Department of Energy  
Albuquerque Operations Office  
P. O. Box 5400  
Albuquerque, New Mexico 87115

Enclosed are the revised pages for the Spook Final Remedial Action Plan (RAP) which reflect the cell design changes described in PID No. 15-S-02. The revisions are typed in bold print and text deletions are indicated by brackets. The sections on the groundwater compliance strategy have not required revisions. We recommend that these pages be incorporated into the Final Spook RAP.

**FIGURE 4.1**  
**PROPOSED TAILINGS CONFIGURATION, STABILIZATION IN PLACE**  
**SPOOK SITE**  
**CONVERSE COUNTY, WYOMING**

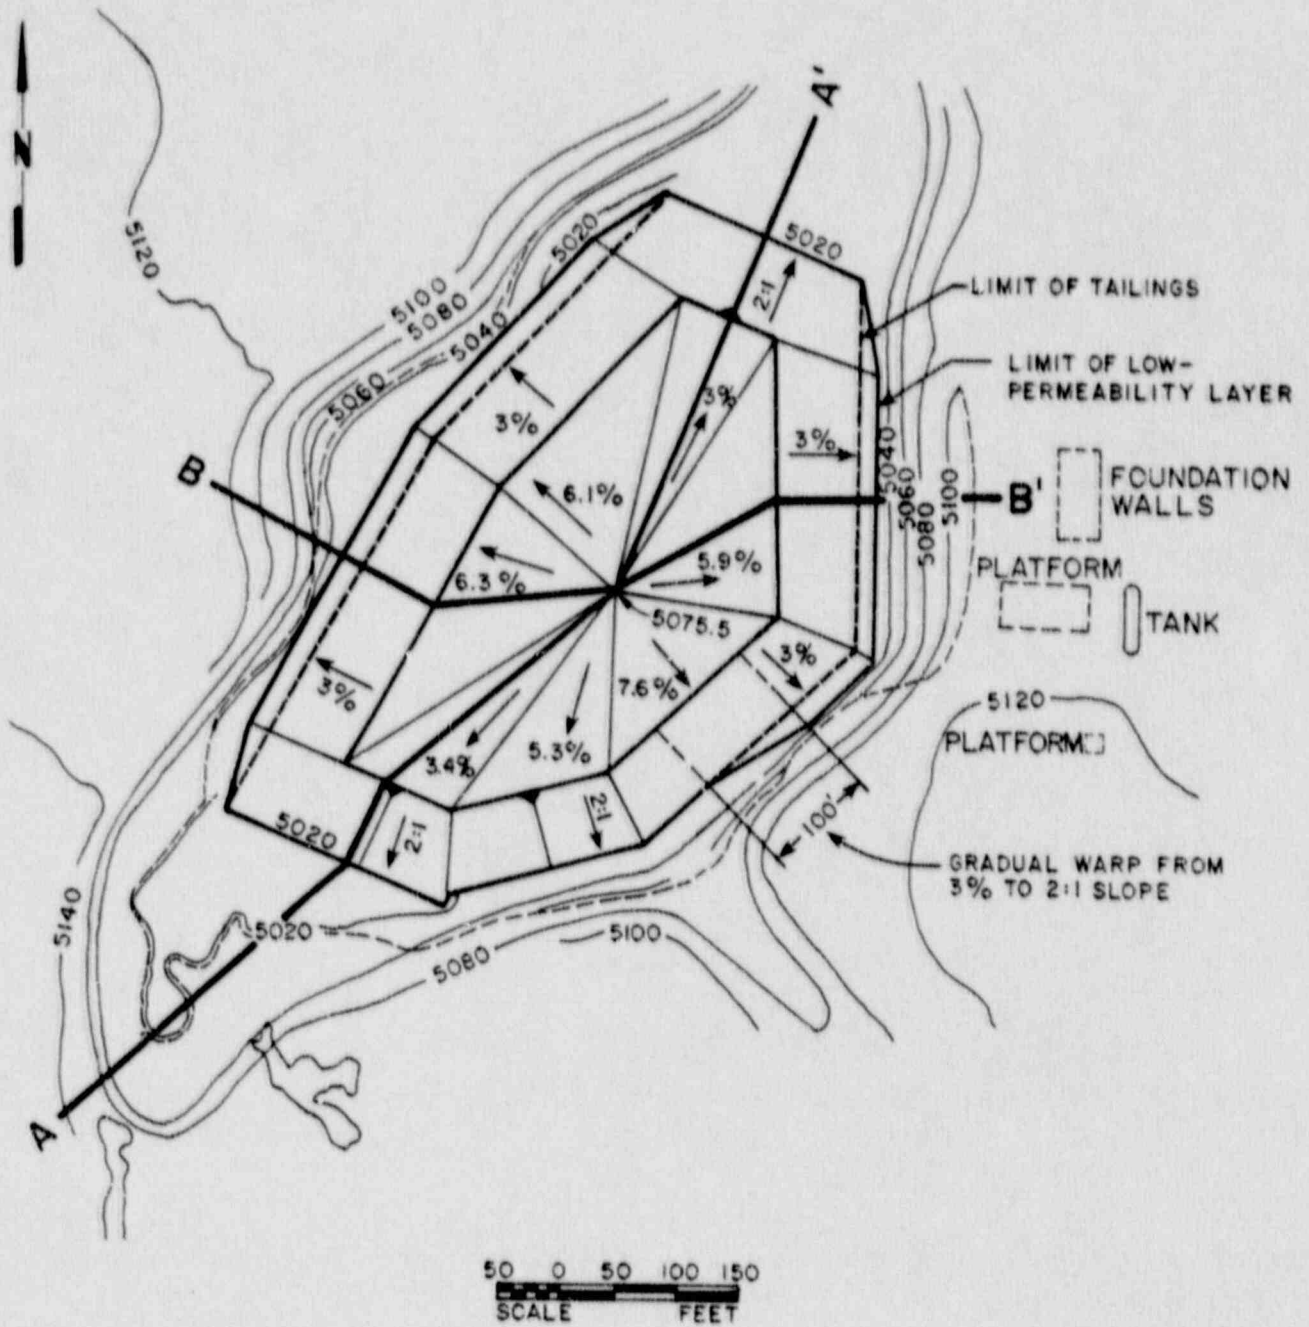
The principal feature of the design is the stabilization of the tailings and contaminated material in the Spook pit, herein defined as "stabilization in place." The disposal cell will have [] topslopes of three to eight percent. On the north and south ends of the pile, the sideslopes will be 50 percent (two horizontal to one vertical); the east and west sides of the pile will be vertical. This will be achieved with concurrent placement of AML materials. The base of the cell will be nearly hexagonal and cover 5 acres inside the pit [] with an average depth of about 40 feet (maximum depth of 54 feet). The proposed cell configuration and a typical cross section are illustrated in Figures 4.1 and 4.2, respectively. The tailings and contaminated materials will be covered with a 1.5-foot-thick low-permeability layer; the upper surface of the layer will be crowned to promote positive drainage, thereby reducing infiltration. Along the perimeter of the vertical sides of the pile, the low-permeability layer will extend 20 feet past the limit of placement of contaminated materials. The bottom of the pit will be covered with a three-foot-thick foundation layer by the state of Wyoming under the state AML Program.

Design detail - The tailings presently rest on the top edge, high-walls, and bottom of the Spook pit; in addition, windblown contamination and contaminated soil under the tailings and in the mill yard are present. All contaminated materials will be placed in the south-central portion of the Spook pit to create a disposal cell with topslopes from three to eight percent. The cell will have 50 percent sideslopes (two horizontal to one vertical) on the north and south ends and be covered with the low-permeability layer. The east and west sides of the cell will be vertical and the low-permeability layer will extend 20 feet past the limit of placement of contaminated materials. The tailings in the pit will be relocated prior to placement of the foundation layer. The proposed pile configuration and a typical cross section are shown in Figures 4.1 and 4.2, respectively.

The topslopes of the cell will vary from three to over seven percent and the sideslopes on the north and south ends of the cell will be 2:1 (50 percent). On the east and west, the cell will have vertical sides.
